# Access Compliance Report Public Rights-of-Way (Curb Ramps)

Main Street: CELESTINE\_CIR Cross Street: LUNA\_CT Location: W

ADA ID: RPAT211029121835 Ramp Type: Type 4 - Parallel Initial Pass/Fail: Pass Overall Compliance: No Severity Score: 10

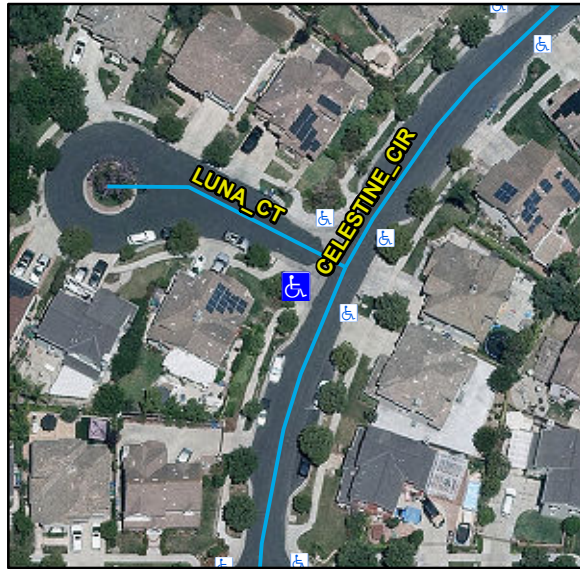
| Compliance | Description                   | Data       | Compliance | Description                   | Data |
|------------|-------------------------------|------------|------------|-------------------------------|------|
| N/A        | Landing Present               | Yes        | No         | DWS Provided                  | No   |
| Yes        | Gutter Ponding                | No         | No         | Curb Slope                    | 10.1 |
| Yes        | Gutter Cross Slope (%)        | 0.3        | No         | Perpendicular Joint Present   | No   |

Remove & Replace Curb Ramp With Two New Directional Ramps or Equivalent.

R304.2.2, R204.3, R305, STD 1115
